2.12 Station Electrical Systems

The information in this section of the reference ABWR DCD, including all subsections, figures and tables, is incorporated by reference with the following departures.

Figure 2.12.15 Instrument and Control Power Supply

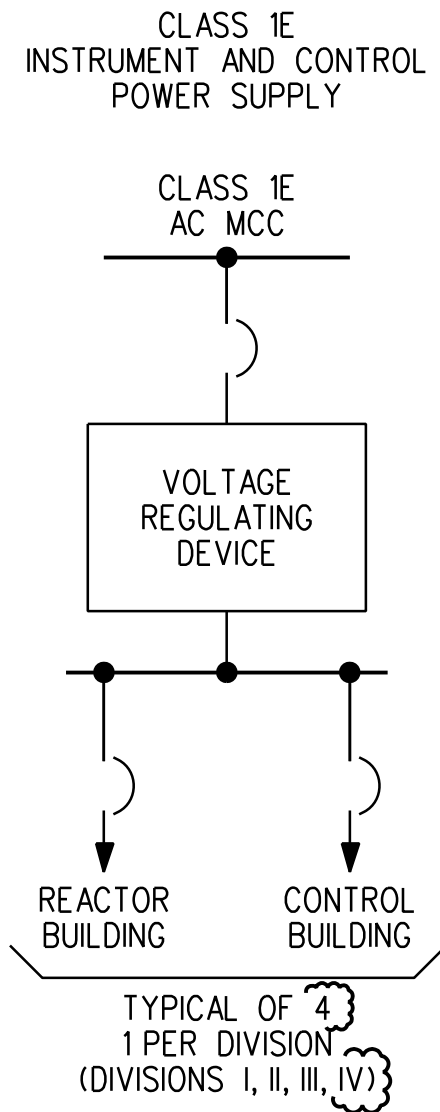
STD DEP T1 2.12-2 (Figure 2.12.15)

STD DEP T1 2.12-2

The Class 1E Instrument and Control Power Supply consists of ~~three~~ four divisions (Division I, II, ~~and III,~~ and IV) of interruptible power supplies with their respective distribution panels. Each Class 1E power supply provides interruptible, regulated AC power to Class 1E circuits which do not require continuity of power during a loss of preferred power (LOPP).
